A d d e n d u m

Iowa Department of Transportation

Date of Addendum: December 18, 2015

B.O.	Proposal ID	Proposal Work Type	County	Project Number	Addendum
001	97-0297-049	BRIDGE NEW - PPCB	WOODBURY	IM-NHS-029-6(201)147--03-97 IM-NHS-029-6(203)147--03-97 IM-NHS-029-6(205)148--03-97 IM-NHS-029-6(206)147--03-97 IM-NHS-029-7(34)148--03-97 IM-NHS-029-7(35)149--03-97 IM-NHS-029-7(40)149--03-97 IM-NHS-029-7(46)149--03-97 IM-NHS-029-7(49)149--03-97 IM-NHS-029-7(58)149--03-97 IM-NHS-029-7(59)149--03-97	22DEC001.A08

Sheet Q.50

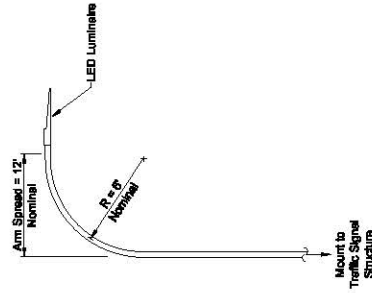
FOU NDATION SOILS DATA Table
Replace FOUNDATION SOILS DATA Table with the
attached FOUNDATION SOILS DATA Table

Foundation Soils Data (C) - Wall 5255 - Q.50				
Wall Station Range =	525593+53 to 525597+42	525597+42 to 525598+42	525598+42 to 525599+92	525599+92 to 525600+37
Factored Wall Contact Stress ¹ =	5,000 psf	4,200 psf	3,750 psf	2,050 psf
Total Unit Weight =	91 pcf ³	79 pcf ³	85 pcf ³	120 pcf
Friction Angle =	26.3° ³	27.7° ³	24.4° ³	0°
Cohesion =	0 psf ³	0 psf ³	0 psf ³	900 psf
Factored Bearing Resistance ² =	8,250 psf ³	7,350 psf ³	5,100 psf ³	3,000 psf
Note 1: Estimated value, based on preliminary information provided by Iowa DOT Soils Design Section.				
Note 2: Strength limit state (factored) bearing resistance value is valid only for a reinforcement length of 0.8 times the maximum wall height along each wall station range. Includes a bearing resistance factor of 0.65.				
Note 3: Foundation soils data within this station range is based on Ground Improvement Engineering's design of IFI elements installed for the IM-NHS-029-6(242)147--03-97 project.

DAVIT STYLE LUMINAIRE ARM FOR TRAFFIC SIGNAL STRUCTURES

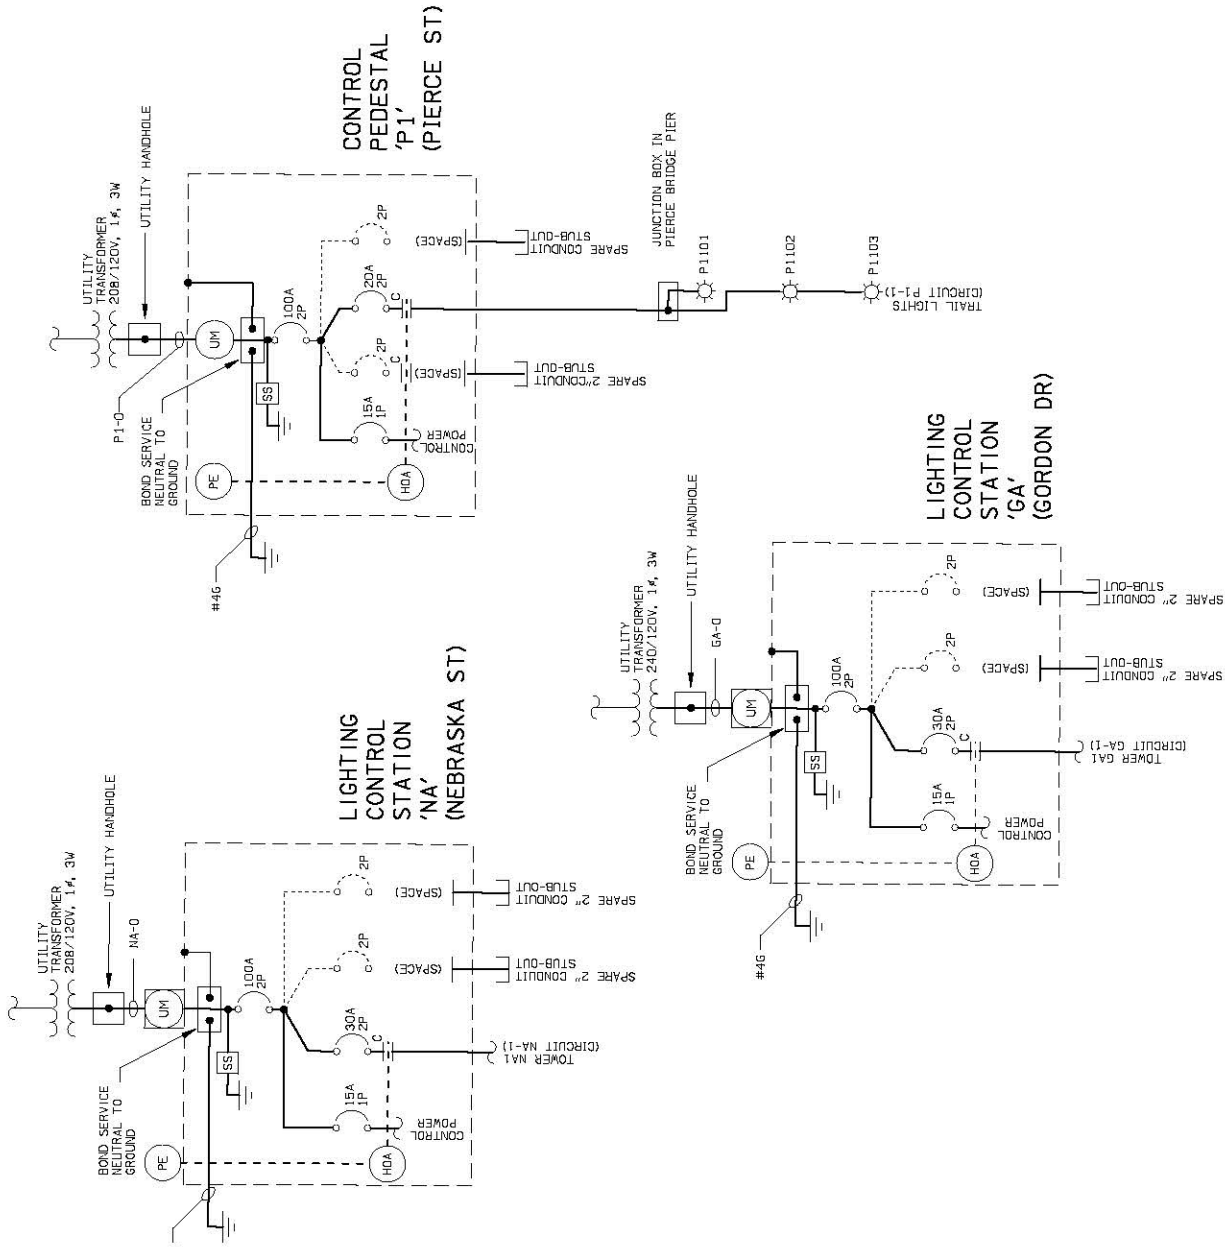
Sheet P.9

Add "DAVIT STYLE LUMINAIRE ARM" Detail and Specifications.
Add Specification for "LUMINAIRE ON TRAFFIC SIGNAL STRUCTURE".

SPECIFICATION DAVIT STYLE LUMINAIRE ARM

Materials: Round, Tapered, Galvanized Steel.
 Finish: Powder Coated.
 Nominal Arm Length (Spread) and Nominal Bend Radius as Indicated.
 Provide with standard 2" dia. (2-3/8" o.d.) x 4" long (min.) slip-fitter tenon for luminaire mounting.
 Luminaire Mounting Height: Refer to N-Sheets.

SPECIFICATION - LUMINAIRE ON TRAFFIC SIGNAL STRUCTURE

Luminaires shall be solid state light-emitting-diode (LED) type.
 Housing: Low Copper Aluminum Alloy.
 Optics: rated IP66 for ingress of foreign material.
 Correlated Color Temperature: 4000K, 70 DRI minimum.
 Minimum Initial Absolute Lumens: 11,700
 Minimum Efficiency: 100 lm/W, 100,000 hours L70
 Driver: Dimmable, Max 1 Amp Drive Current, Surge Protected.
 Input Voltage: 120 - 277 VAC, self-adjusting.
 Luminaire Ambient Temperature Rating: -40 deg C to +40 deg C.
 Light Distribution: IES Roadway Type 2, Medium, Cutoff.
 Luminaire Finish: Manufacturer's Standard Gray.
 Provide with NEMA Floodproof control receptacle and photocell.
 Listed Warranty: 5 Years.
 Acceptable Manufacturers:
 AEL Autobahn ATB2-40BLEDE10-MVOLT-R2-P5
 Philips Lumec Roadfocus RFW-1000R48
 Lectek GGNZ-40-NV-TM-Z-61-PA-PDRS.
